Docket Item # 4 & 5
BAR CASE # 2016-0322 & 0323

BAR Meeting
October 19, 2016

ISSUE: Partial Demolition, Addition/Alterations and Waiver of Rooftop HVAC Screening Requirement

LOCATION: 609 Cameron Street

1 Site Plan, 609 Cameron Street
A-1 1" = 10.0'

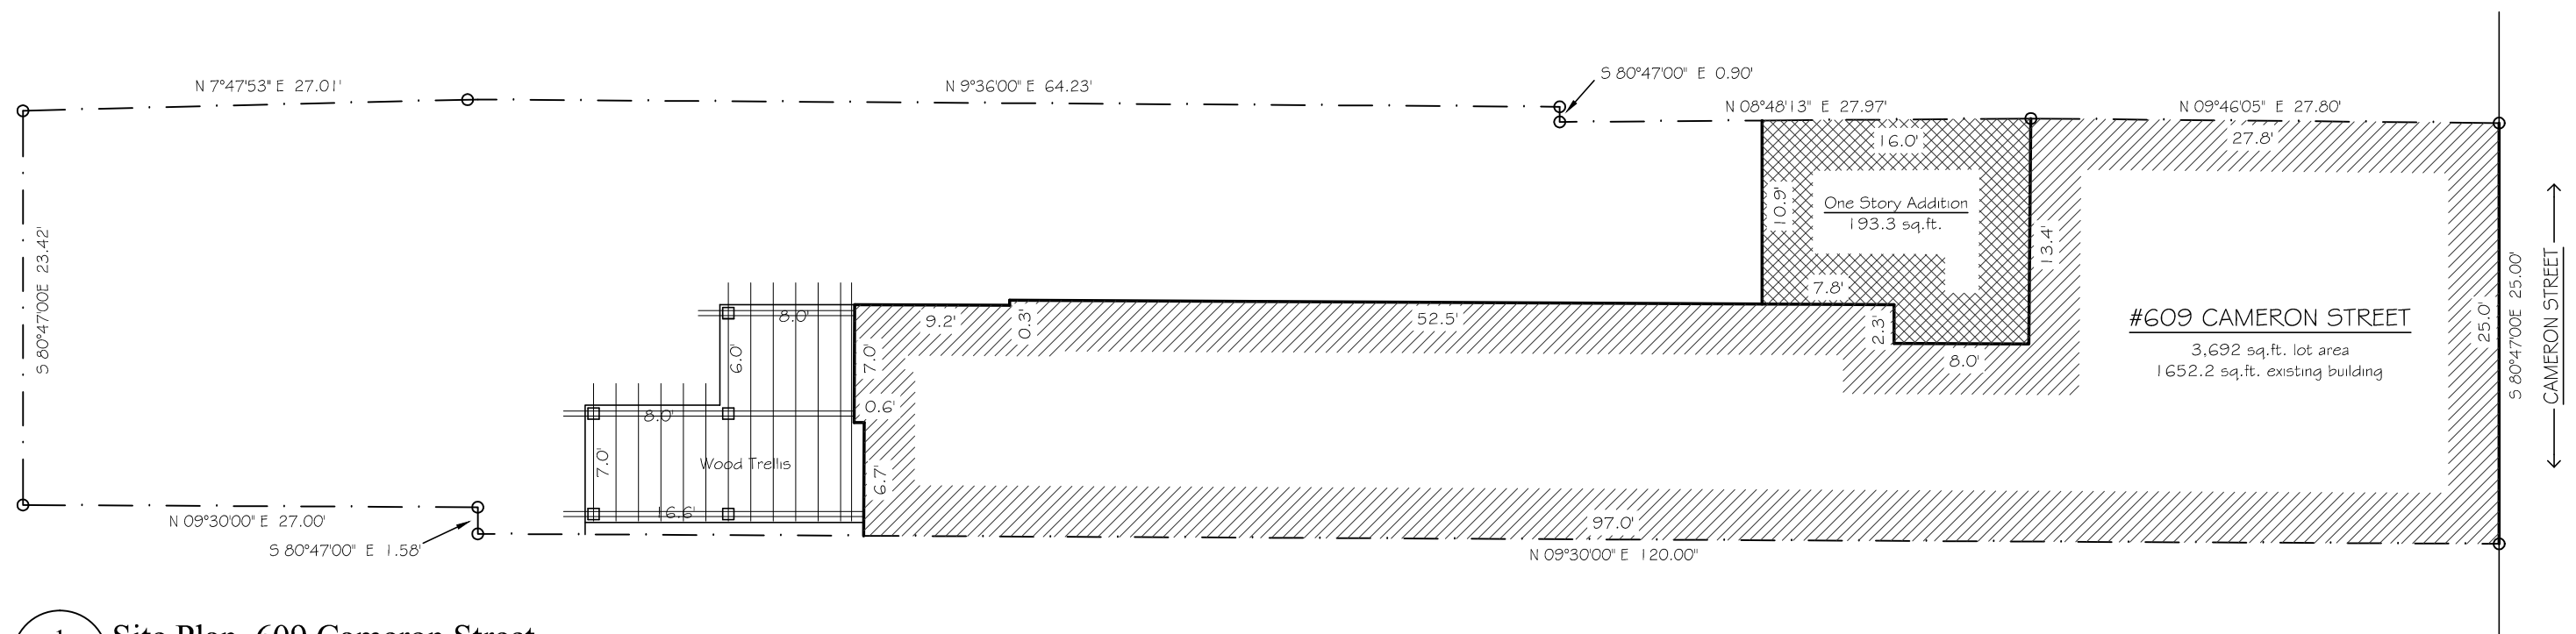
C-1 Based on the submitted site plan and plat, the proposed project will comply with zoning. The open space calculation appears to be incorrect. Staff calculates 1778.96 square feet of open space. Applicant should submit an open space plan to confirm.

C-2 Applicant must resolve the discrepancy between the lot area on the plat (3,692 square feet) and the square footage in real estate records (3,675 square feet) prior submitting for building permit.

Applicant should reconcile information with zoning staff prior to submitting for building permit.
